CITY OF ALBUQUERQUE

RE: 1200 Lomas Blvd. NE
Grading & Drainage Plan
Engineer's Stamp Date: 05/10/21
Hydrology File: J15D101

Based upon the information provided in your submittal received 05/10/2021, the Grading & Drainage Plan **is not** approved for Paving Permit. The following comments need to be addressed for approval of the above referenced project:

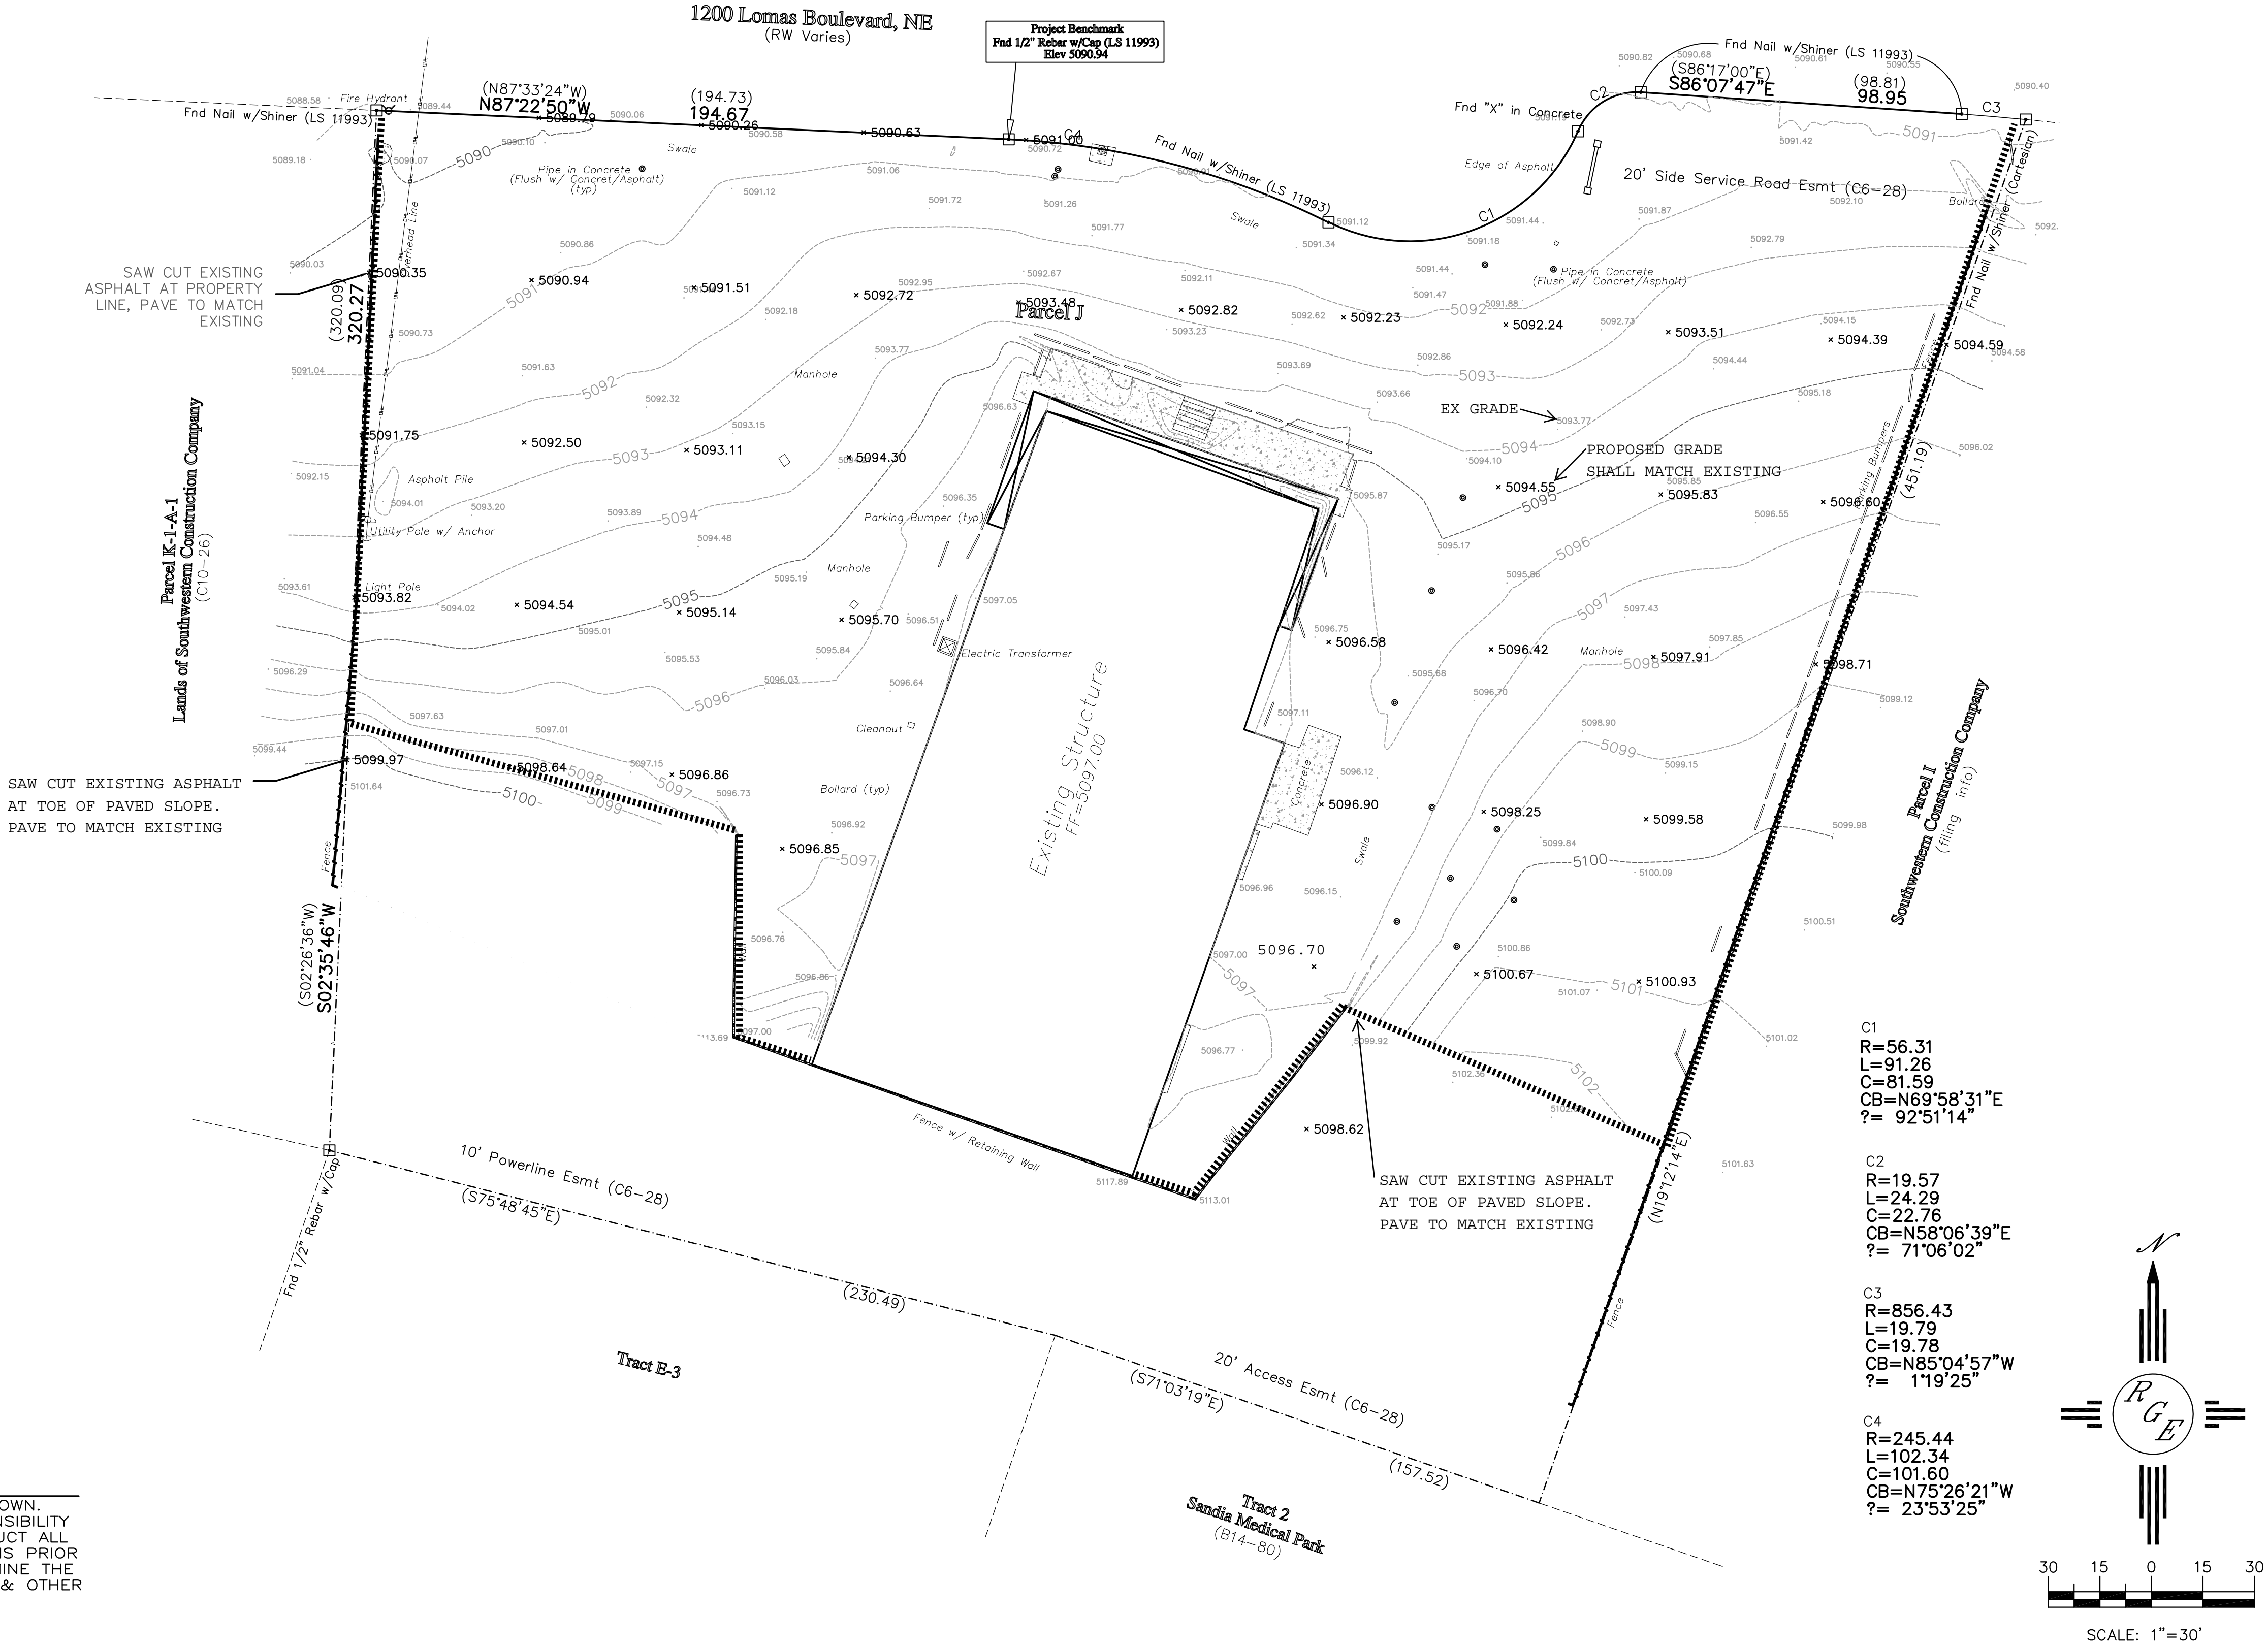
1. Under the Drainage Narrative it states, "...No Water Quality Ponding Requirement is proposed." This is not correct, please provide management onsite for the Stormwater Quality Volume (SWQV) in accordance with the new drainage ordinance, § 14-5-2-6 (H) enacted 10/2/18 (Council Bill C/S O-18-2). Please follow the DPM (signed 06/08/20) Article 6-12 Stormwater Quality and Low-Impact Development for the sizing calculations. Since this project is a redevelopment, calculate the required SWQV by multiply the impervious area by 0.26 inches.
2. If the Owner elects to do a payment-in-lieu for the required SWQ volume, than please add a note which states, "The Owner has elected to pay the Payment in Lieu for the required Stormwater Quality Volume (XX CF *\$8/CF = \$xx.xx.)"
3. Please provide missing survey information within Lomas R.O.W. (please see image below)
